# IEEE802.3da standard review

10/15/2025

Figure 189-9—Top level MPD state diagram continued, part b

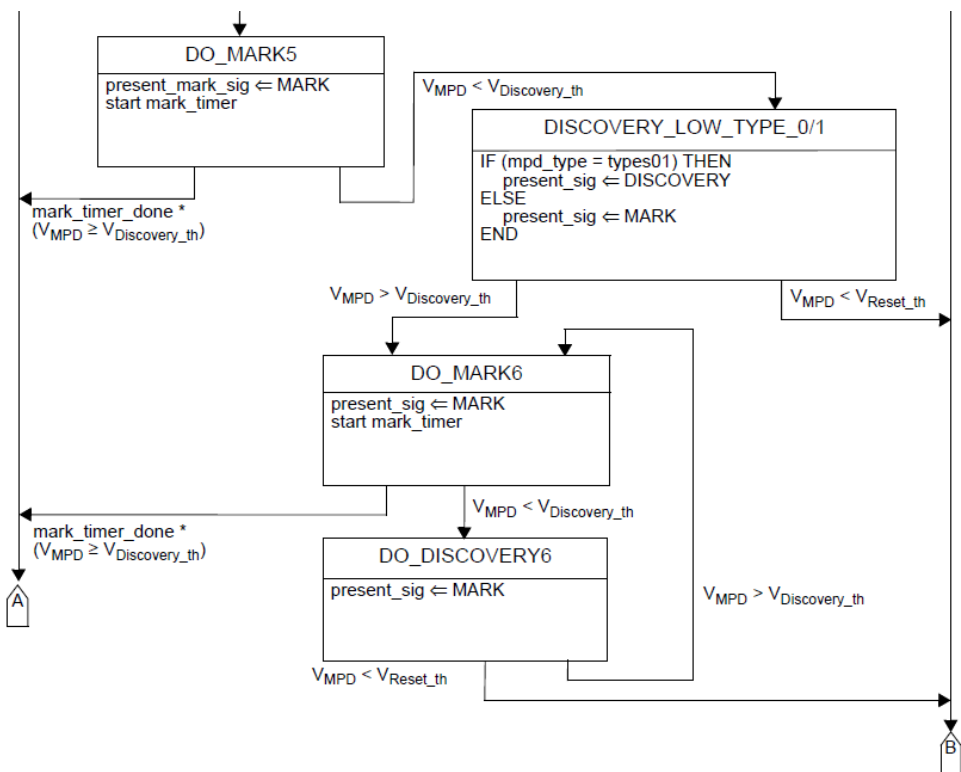
Clause/Table	Issue	Suggested remedy	Notes
Table 189-8	Flow chart on Fig 189-9 has 6 events of discovery however in a table 189-8 there are 5 events of discovery.	Make note to the table 189-8: Option 1: Discovery Event 6 does not add additional discovery information and could be used for future application. Option 2 (from Michael Paul presentation MPoE Discovery Extensibility) : Bit 6 =0 signals that the information was for T1M multidrop

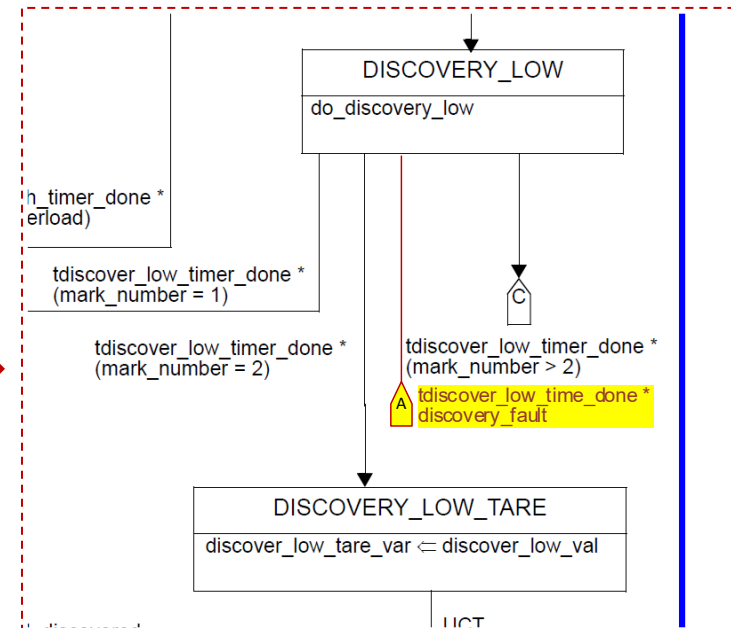
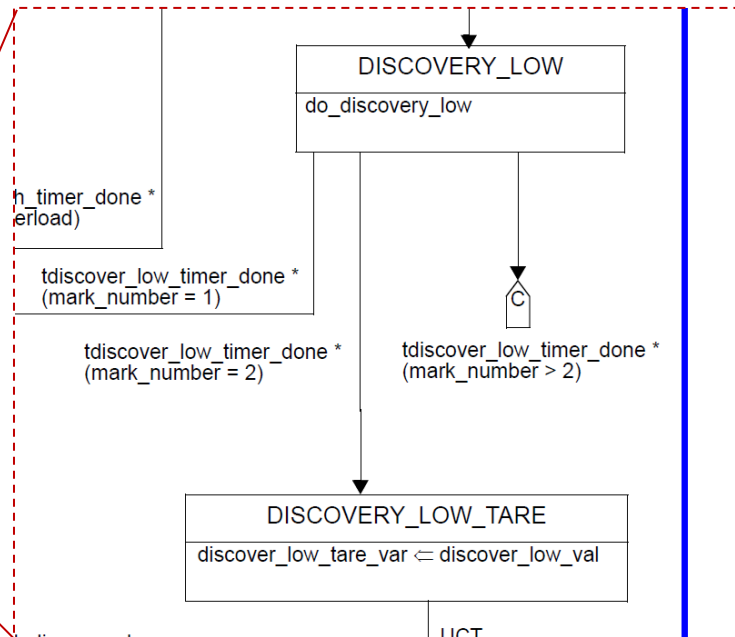
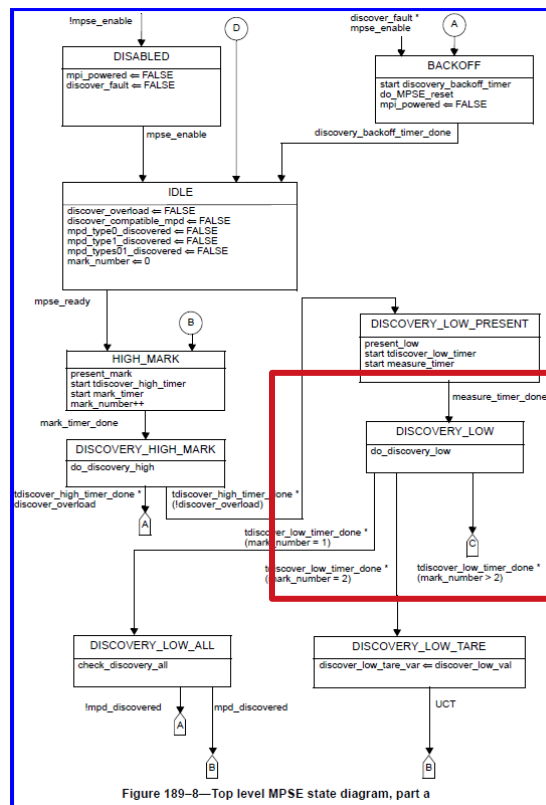
Clause/Table	Issue	Suggested remedy	Notes
Figure 189-8	Overload during DISCOVERY_LOW is not covered in the state-machine	Add an exit to "A" (backoff) from "DISCOVERY_LOW" if "discovery_fault" is received from "do_discovery_low"
